Information Need No. AE-20 **ER Figure 3.4-3, 3.4-11**

Figure 3.4-3 Circulating Water System Intake/Discharge Structure Location Plan

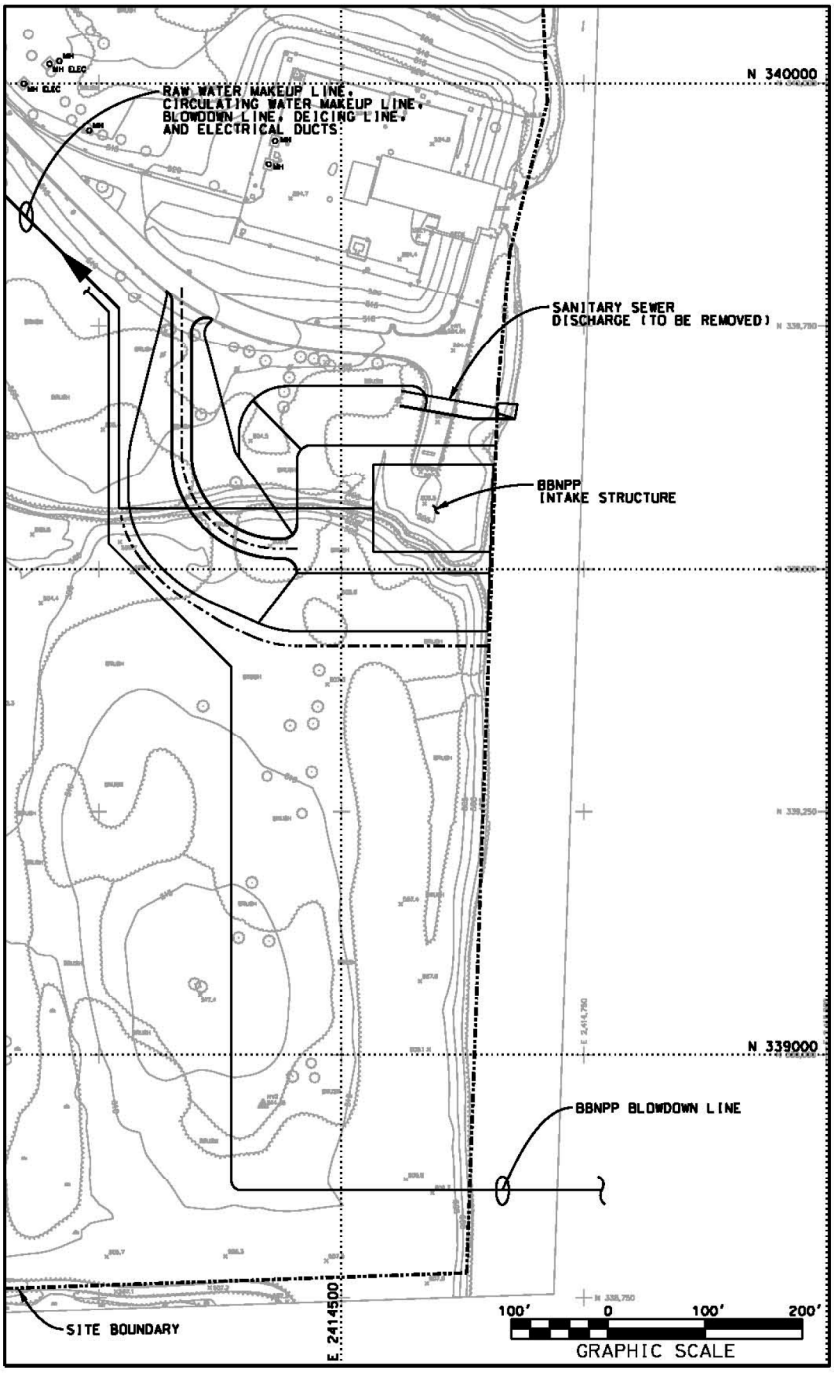
Provide a knowledgeable expert to discuss the existing sanitary sewer discharge upstream of the proposed location of the BBNPP intake system.

Figures 3.4-3 and 3.4-11 show a "Sanitary Sewage Discharge (to be removed)." This is presumably the line from the Current SSES Sewage Treatment Plant.

A knowledgeable expert will be available during the audit to discuss the existing sanitary sewer discharge upstream of the proposed location of the BBNPP intake system.

A large, new sanitary sewer line is being installed in the vicinity of the SSES plant along US Route 11. The new line is owned by the Berwick Area Joint Sewer Authority. The line will discharge into a treatment plant located in the Borough of Berwick. The sanitary sewer from the SSES plant presently discharges into the Susquehanna River. PPL is reviewing the option of connecting the SSES sanitary sewer line to this new line.

It is not planned for the sanitary sewer to continue to discharge into the river at the current location because of the possibility of the sanitary wastewater being drawn into the BBNPP intake.
